Intermodal Logistics Centre at Enfield

MODIFICATION APPLICATION

ILC –E – PT3A – Modification Application No. 3
REV A

31 August 2009

CIVIL WORKS PACKAGE
DRAINAGE CATCHMENT AND
OVERALL SITE PLAN

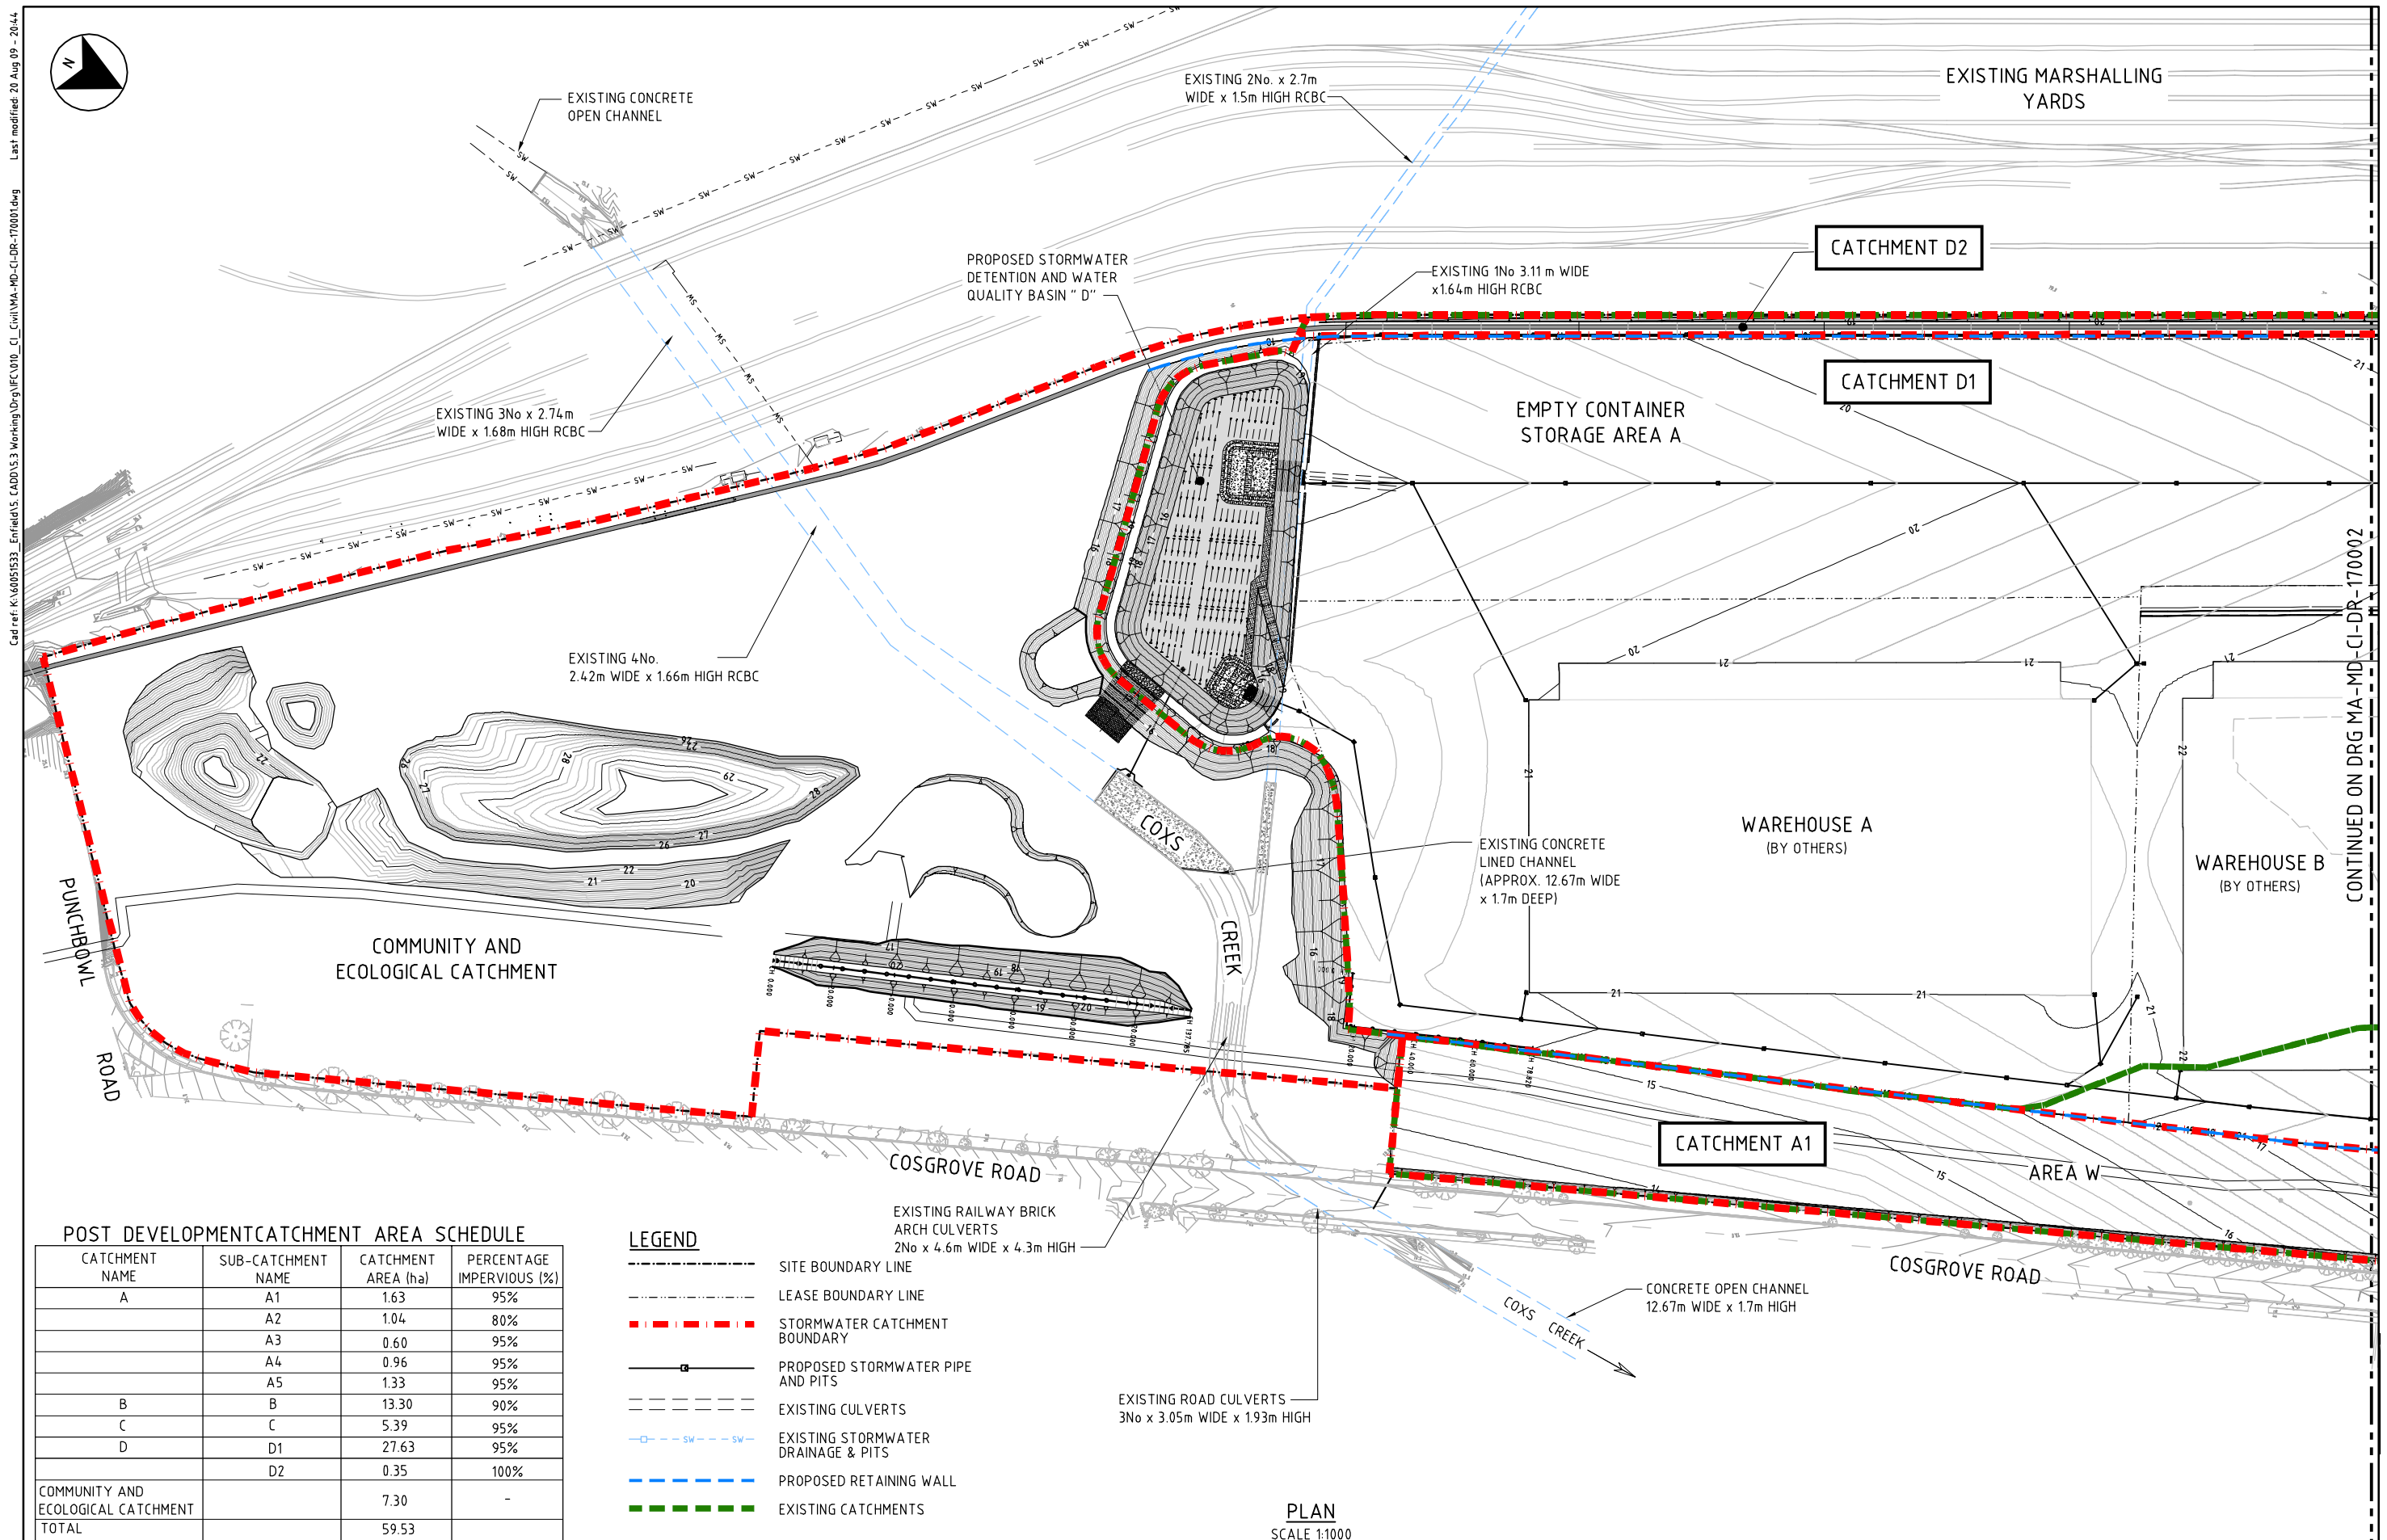
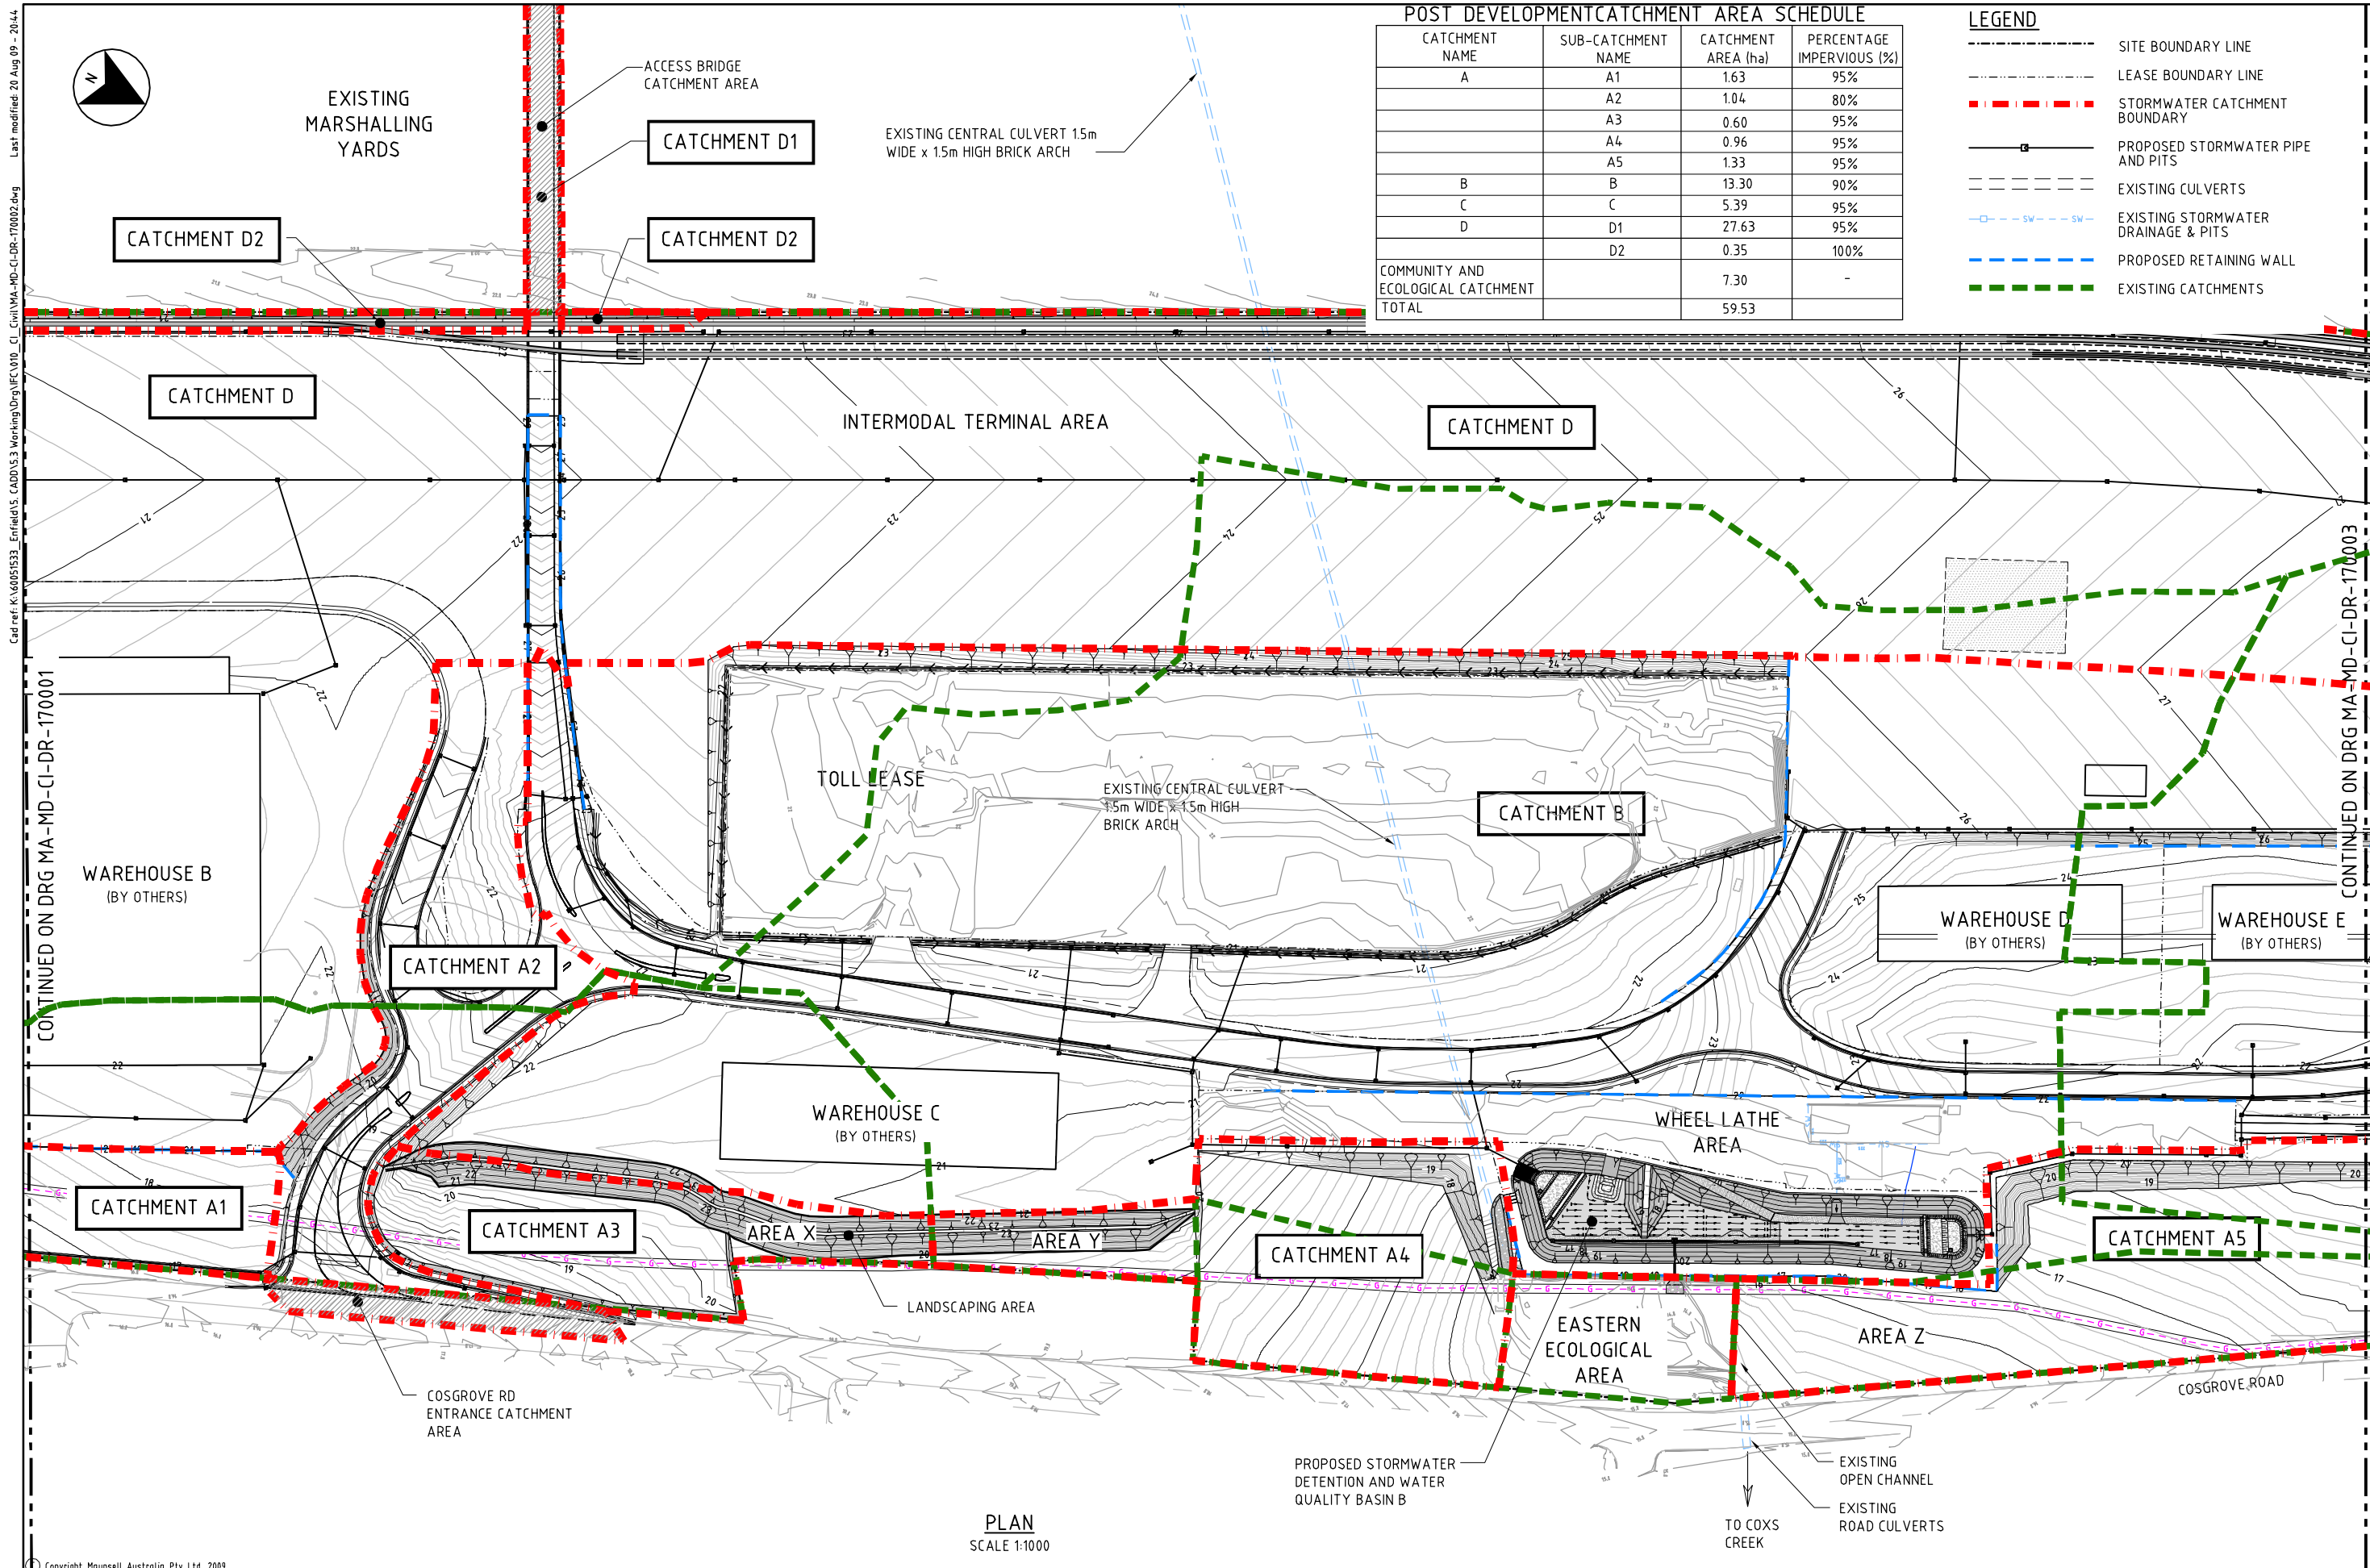
Some adjustments have been made to the detention basin catchment areas, locations and sizes (refer drawings MA-MD-CI-DR-170001 to 170003 in Appendix C) as part of the detailed design. The modified detention basin arrangement remains consistent with the approved development, comprising three above ground basin storages located downstream

- The volume of Basin B has increased from 8,000 m³ to 8,582 m³.
Basin B has been relocated to a position approximately 100 m to the north of its approved location to avoid encroachment on the existing central stormwater culvert and to improve access to the basin for maintenance. This has resulted in an increase in the area of the Light Industrial Commercial (LIC) precinct Y and a reduction in LIC Precinct Z (further described in Sections 5 and 6).
- The volume of Basin C has increased from 700 m³ to 1,400 m³.
- The volume of Basin D has reduced from 16,600 m³ to 14,760 m³.

Sydney Ports requests that Conditions 1.1 and 2.31 of the Project Approval refer to the modified basin arrangement discussed in this document.
